Sundry Notices and Reports on Wells

5. Lease Number  
NMSF-077482
6. If Indian, All. or  
Tribe Name
7. Unit Agreement Name
8. Well Name & Number  
Jaquez Jose 1S
9. API Well No.  
30-045-33602
10. Field and Pool  
Basin Fruitland Coal
11. County and State  
San Juan Co., NM

☒ Other - Change to Directional Drill

Want to change this well from a vertical drill to a directional drill well. Want to add the BH Unit O (SWSE), 1300' FSL & 2460' FEL, Section 24, T30N, R12W, NMPM.

### WELL LOCATION AND ACREAGE DEDICATION PLAT

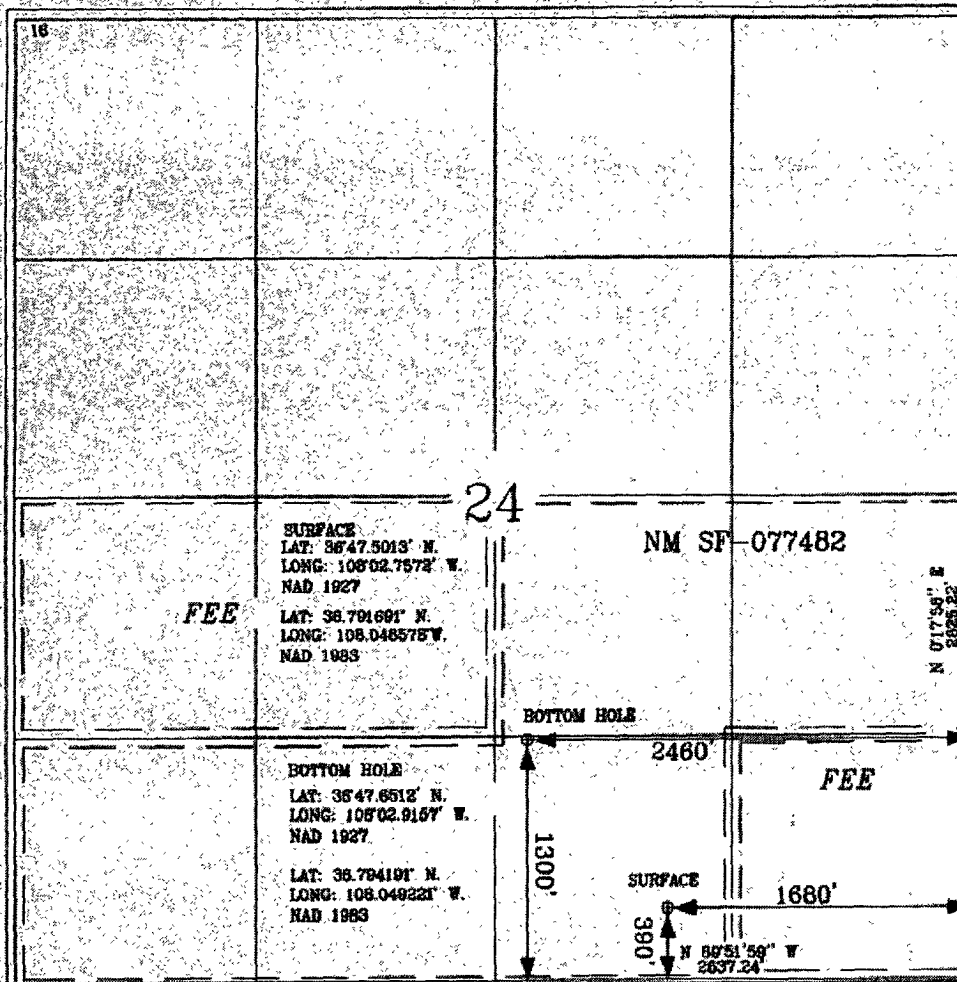
Attached is a new plat C-102, directional drill plan and directional drill survey.

| UL or lot no. | Section | Township | Range | Lot Idn | Feet from the | North/South line | Feet from the | East/West line | County   |
|---------------|---------|----------|-------|---------|---------------|------------------|---------------|----------------|----------|
| 0             | 24      | 30-N     | 12-W  |         | 1300'         | SOUTH            | 2460'         | EAST           | SAN JUAN |
